DOMINION VIRGINIA POWER
NORTH ANNA UNIT 3 COMBINED LICENSE APPLICATION
SRP 03.07.01: RESPONSE TO RAI LETTER 81

Supplemental Response to NRC RAI Letter 81

RAI 5942 Question 03.07.01-5

Supplemental Response to RAI QUESTION NO.: 03.07.01-5

Figure 3.7.1-5-1: Generic Vs Values Superimposed on FSAR Figure 2.5-241g

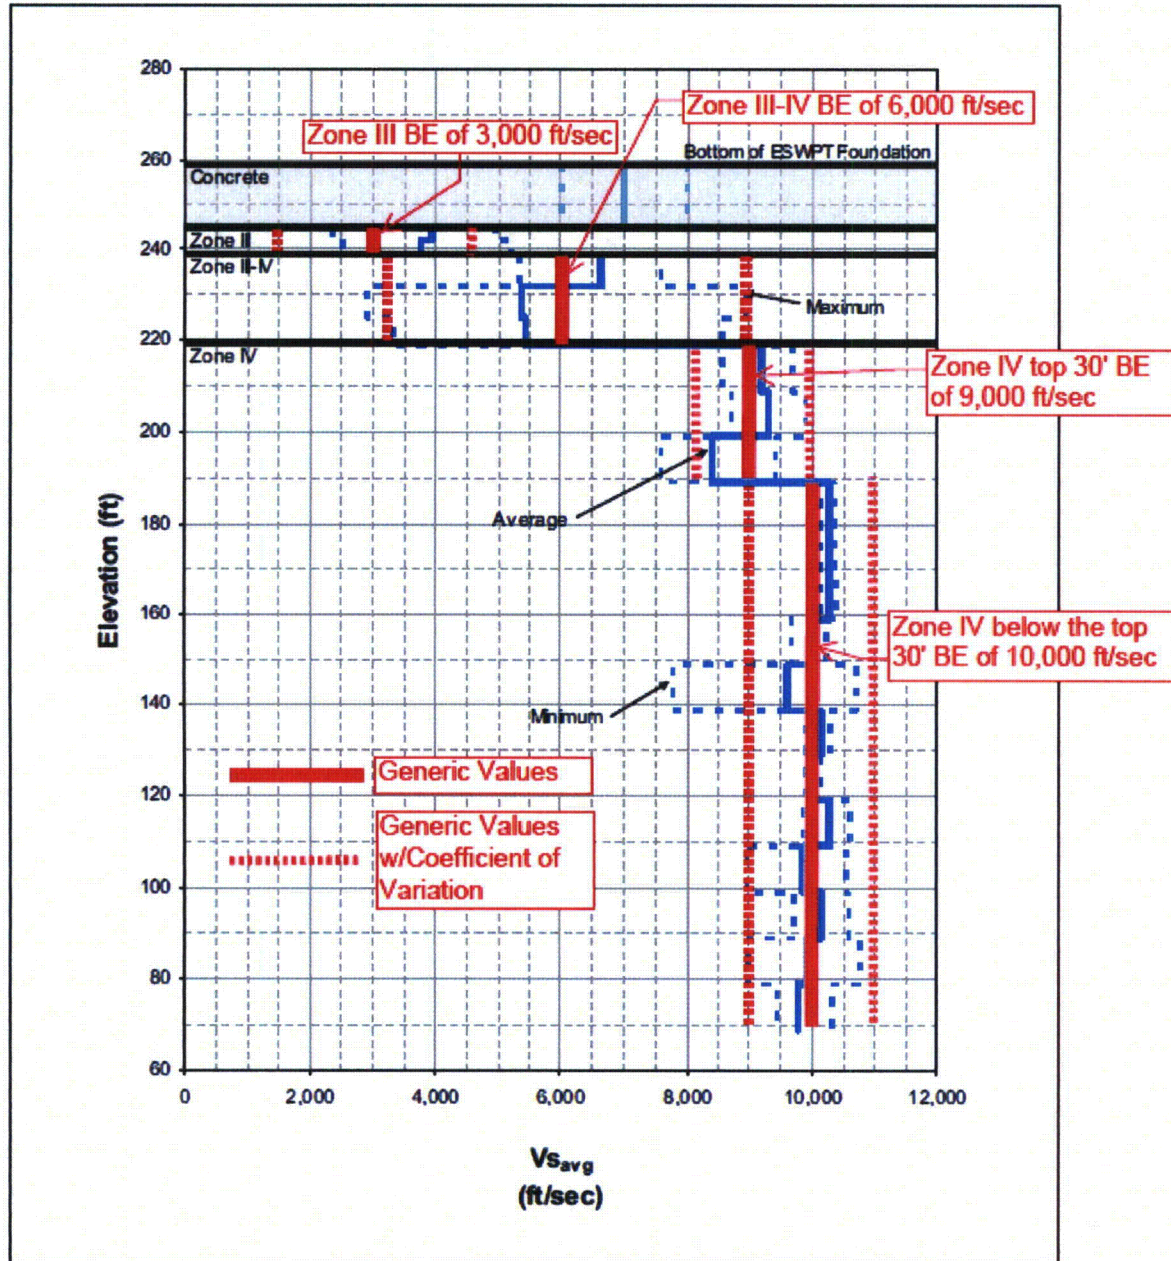
For the concrete fill beneath the East ESWPT, the best estimate value of V_s is 7,000 ft/sec (see FSAR Table 2.5-212), with lower and upper bounds of 6,000 ft/sec and 8,000 ft/sec, respectively (see FSAR Section 2.5.4.7.1). These values are represented on the V_s profile for the East ESWPT on FSAR Figure 2.5-241g. A similar generic approach could have been adopted to obtain a generic value for the average, and lower and upper bound V_s values for the rock/soil zones beneath the concrete fill, since, as noted in the initial response to RAI 02.05.02-3, the rock/soil zones at the North Anna site have defined V_s ranges, as tabulated below. That is, each rock/soil zone could have been assigned only one generic average value, one lower bound (minimum) and one upper bound (maximum) V_s value for their entire thickness.

The average of the Zones III and III-IV values from this table are 3,000 ft/sec and 6,000 ft/sec, respectively. For Zone IV, the average value is 9,000 ft/sec as depicted on FSAR Table 2.5-212. This value is representative of about the top 30 ft of Zone IV. The average V_s value increases to approximately 10,000 ft/sec below the top 30 ft (approximated from FSAR Figure 2.5-237). The attached figure (Figure 3.7.1-5-1) shows these generic average values superimposed for each rock zone on FSAR Figure 2.5-241g. There is generally good agreement with the existing average values on FSAR Figure 2.5-241g obtained from Method 2, which is described in more detail later.

Although the method described above provides a reasonable V_s profile for the East ESWPT, it does not directly include any of the V_s values measured in the three V_s borings closest to the structure nor does it account for the general increase in V_s as depth increases. Method 2, described below, averages the V_s values from these V_s borings and estimates lower and upper bounds based on the variation of the measured values. As shown in Figure 3.7.1-5-1, the results are generally similar to those obtained using the generic values derived for each zone, but show local variation within each zone, thus providing the most appropriate estimate of the V_s profile since the V_s variations within each zone will be accounted for in the SHAKE analysis.
